Docket Number:	16-AFC-01
Project Title:	Stanton Energy Reliability Center
TN #:	223281
Document Title:	Stanton Energy Reliability Center LLC's Response to PSA Workshop Queries
Description:	N/A
Filer:	Marie Fleming
Organization:	DayZen LLC
Submitter Role:	Applicant Representative
Submission Date:	4/26/2018 8:03:24 AM
Docketed Date:	4/26/2018

Application For Certification
**STANTON ENERGY RELIABILITY
CENTER**

**STANTON ENERGY RELIABILITY
CENTER, LLC's RESPONSE TO PSA
WORKSHOP QUERIES**

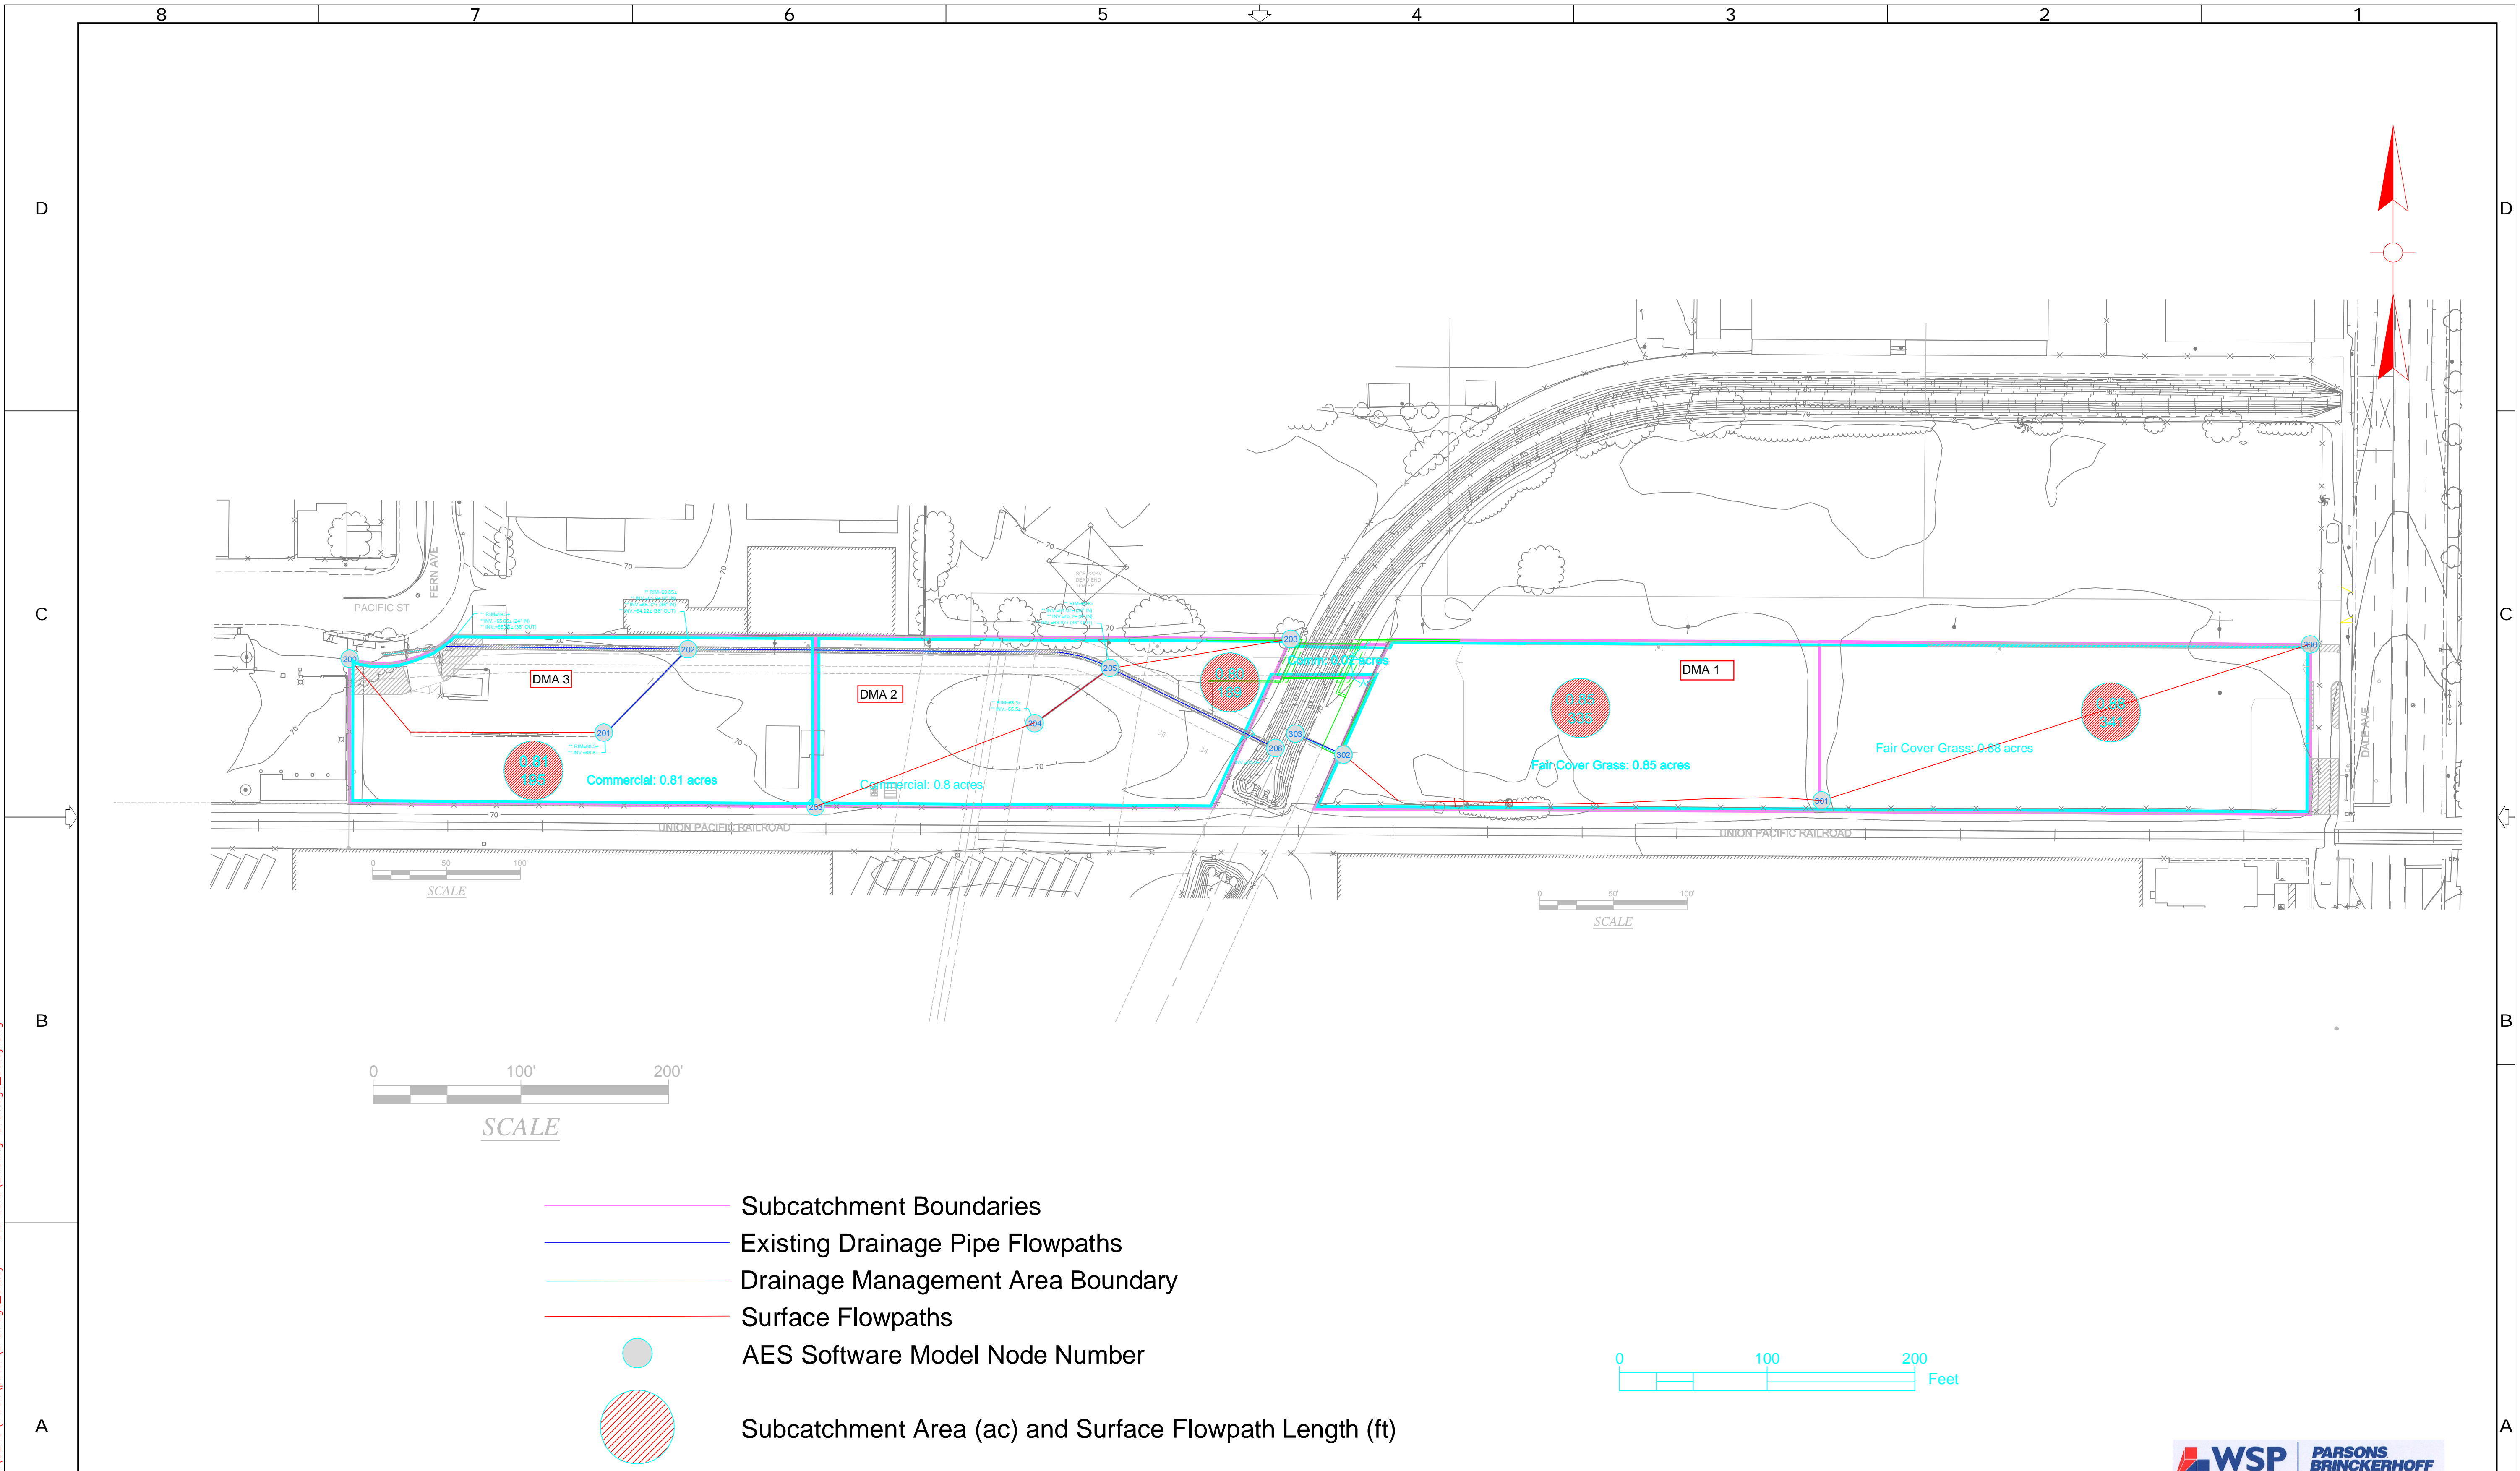
Staff requested information relating to the 100-year hydrologic analysis to demonstrate no net increase in peak flows.

SERC, LLC is providing the 100-year Existing and Proposed Rational Method, and the Proposed and Routed Hydrographs. See Attachments A, B and C. For ease of reference, Hydrology Maps for Existing System and Proposed System are included in Attachment E.
